CITY OF ALBUQUERQUE

RE: Lot 2 Block 2 Unit 18 SAD 228 6612 Petirrojo NW Volcano Cliffs Subdivision Grading and Drainage Plan Engineers Stamp Date 4/27/2021 (D10D003G2P)

Based upon the information provided in your submittal received 4/30/2021, this plan is approved for Grading Permit.

Lot 2 Blk 2 Un 18 VC 6612 PETTIROJO ROAD GRADING AND DRAINAGE PLAN

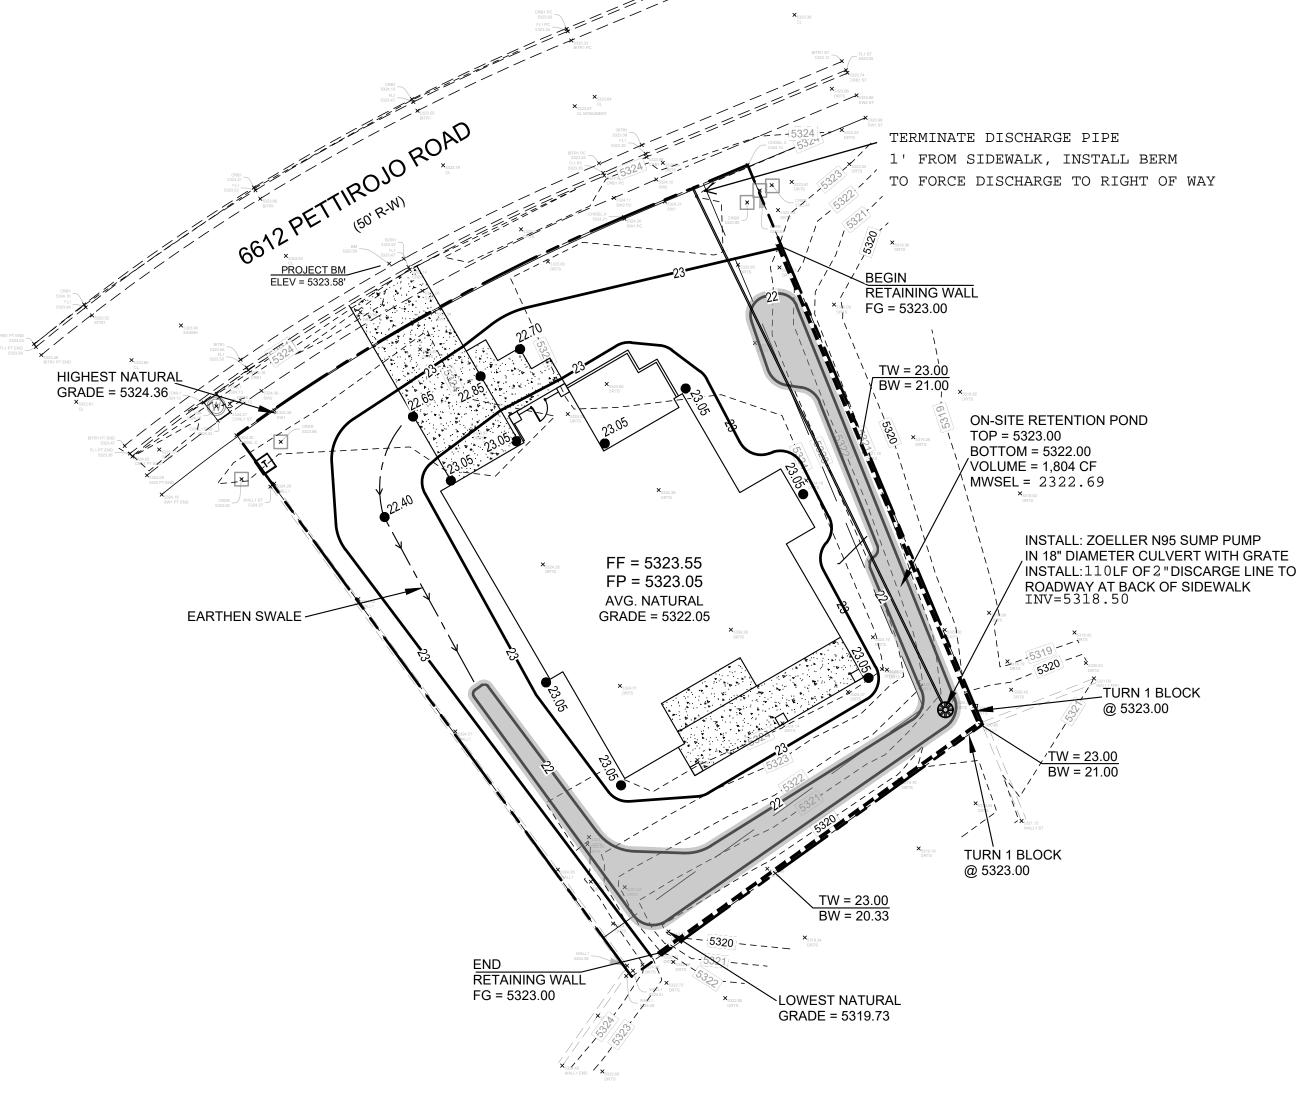
Prior to Building permit approval a Pad Certification will be required, provided by the Engineer or a registered Land Surveyor.

Advise the owner contractor not to use dirt as a ramp to climb the curb, use lumber or crusher fines for this purpose.

Reiterate to the Owner/Contractor that a separate permit for a garden/retaining wall must be obtained with the approved G&D plan and Pad Certification. Also, if a swimming pool is to be placed the grading and drainage plan will change and will need to be resubmitted.

Prior to Certificate of Occupancy release, Engineer Certification per the DPM checklist is required.
